**RE: PPSSCC-109 - Development Application DA 1611/2020/JP- Demolition of existing structures and construction of a 13 and 18 storey Residential Flat Building Development, containing 196 units, basement car parking and associated works – 6-18 Garthowen Crescent, Castle Hill**

PDK Urban Planners Pty Ltd (**PDK**) has been engaged by several of the residents of 9 and 11-13 Garthowen Crescent, Castle Hill (**Clients**) to review Development Application DA 1611/2020/JP (**DA**) which is for the “*Demolition of existing structures and construction of a 13 and 18 storey residential flat building development, containing 196 units, basement car parking and associated works.*” (**Proposal**) on the property known as 6-18 Garthowen Crescent, Castle Hill (**Property**) and to subsequently make this submission to The Hills Shire Council (**Council**) and subsequently to the Sydney Central City Planning Panel (**Panel**).

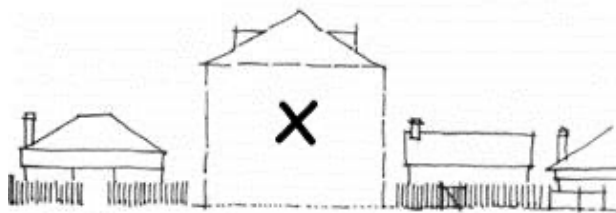
Further Section 3.5 of Part C4 of the DCP expressly states in writing and diagrammatically that:

*“New buildings on land adjoining a heritage building should be sympathetic in terms of siting, scale, proportions, materials and colours.”*

In support of such a statement, Section 3,5 of Part C4 of the DCP incorporates the following diagram to further enforce such a statement:
